# Detailed Site Plan Dash In – Mill Branch

## DSP-20003-01

STAFF REPORT

SUBJECT: Detailed Site Plan DSP-20003-01  
Type 2 Tree Conservation Plan TCP2-044-2021-01  
Dash In - Mill Branch

# DETAILED SITE PLAN

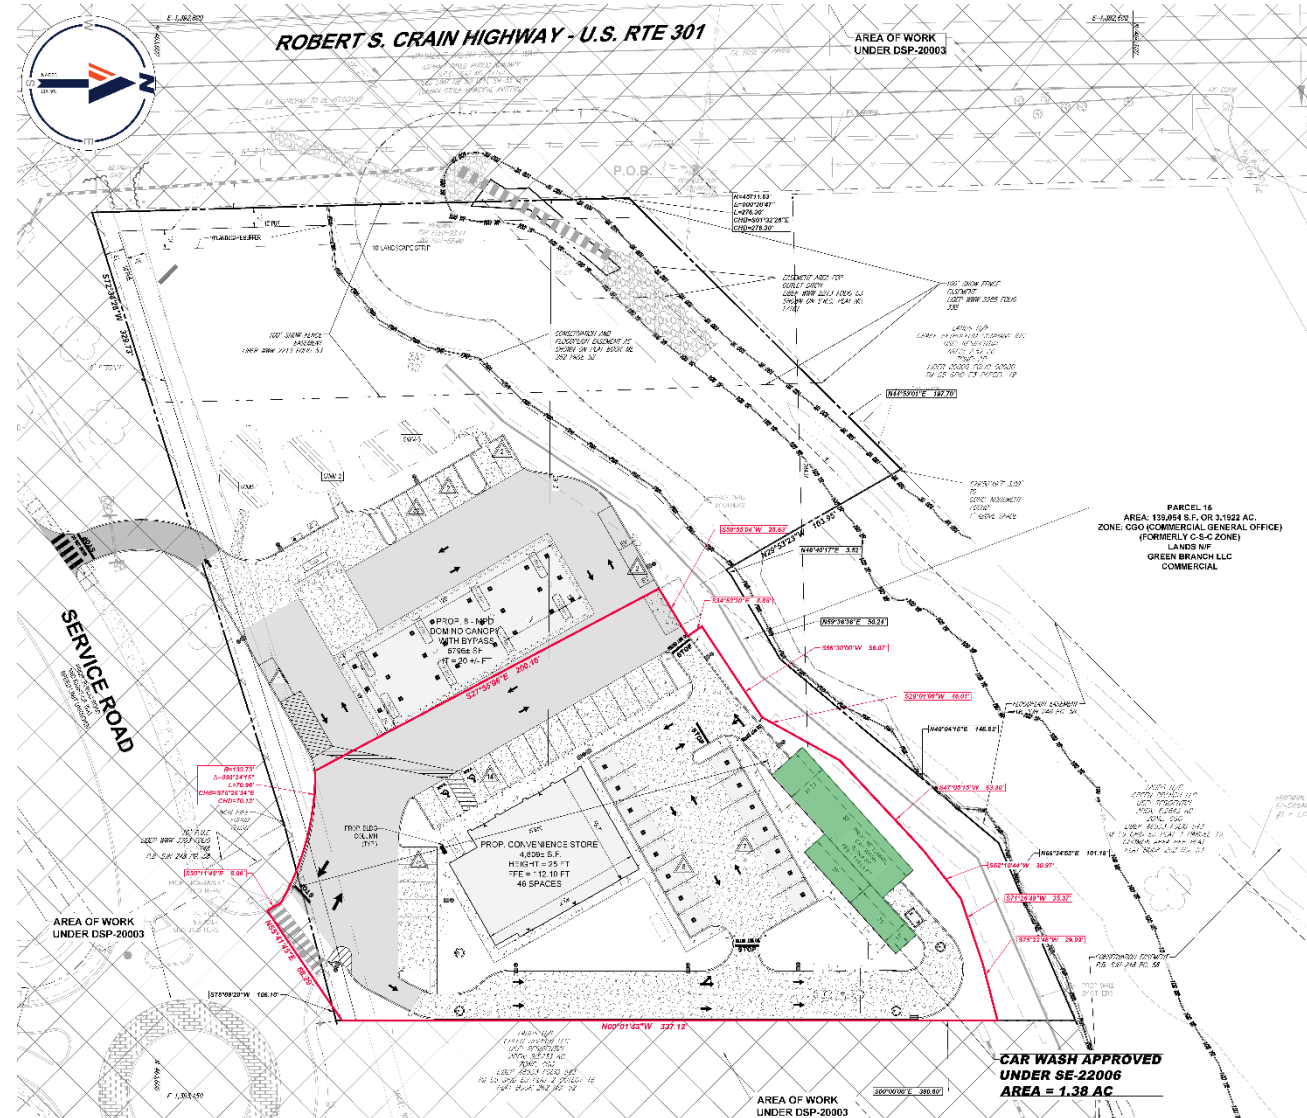
The total number of required parking spaces is 32, whereas the site plan reflects only 31. Prior to certification, the applicant will need to either reduce the total gross floor area of the convenience store, or provide the minimum required number of parking spaces on-site. The parking calculations should also be revised to reflect the correct number of required parking spaces.

In order to provide safe pedestrian movement on-site, staff recommend that a direct pedestrian route be provided from the sidewalks shown within the right-of-way at the site access point to the proposed sidewalks surrounding the building. The pedestrian route shall be clearly defined and should include striped crosswalks when crossing any drive aisles and any associated ADA ramps where necessary.

- d. Revise the Parking Requirements on Sheet DSP-4 to list the minimum required number of parking spaces for the proposed convenience store to be 30, and the total number of required parking spaces to be 32.

- e. Provide the minimum required number of parking spaces on-site, or reduce the total gross floor area of the convenience store to conform to the parking requirements in Section 27-568(a) of the prior Prince George's County Zoning Ordinance.

- j. Provide a dimension between the proposed bicycle racks and the proposed building column, to ensure that a minimum 5-foot-wide clear pedestrian path is provided around the food or beverage store.

- k. Provide a direct pedestrian route to the entrance of the building that shall include striped crosswalks crossing any drive aisles and associated Americans with Disabilities Act ramps where applicable.

# LANDSCAPE PLAN

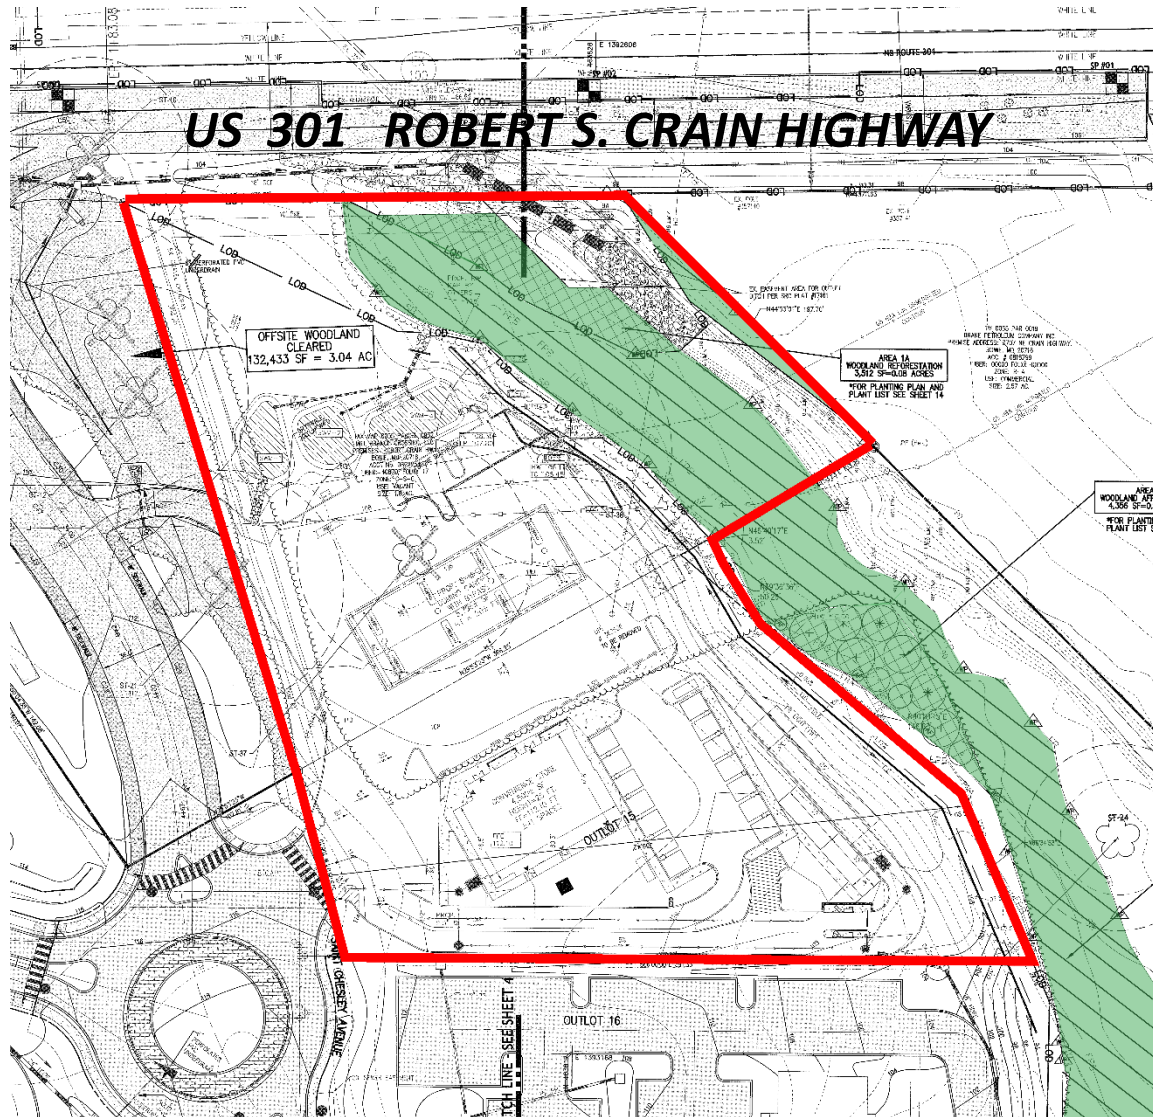
The schedule for Section 4.7, Buffering Incompatible Uses, lists 13 shade trees as being provided to meet the minimum requirements. However, the landscape plan only shows 12 shade trees along the property line abutting residential zoned property. The landscape plan shall be revised to show the minimum number of required plant units, in accordance with Section 4.7 of the Landscape Manual.

Section 4.9 of the Landscape Manual requires that a percentage of plants within each plant type (including shade trees, ornamental trees, evergreen trees, and shrubs) shall be native species. Specifically, 50 percent of shade and ornamental trees, and 30 percent of evergreen trees and shrubs are required to be native. The landscape schedule shows 38 shade trees, 4 ornamental trees, and 200 shrubs. However, the Section 4.9 schedule on the landscape plan includes only 25 of the proposed 38 shade trees and 189 of the proposed shrubs. The schedule shall be revised to include all proposed plant types.
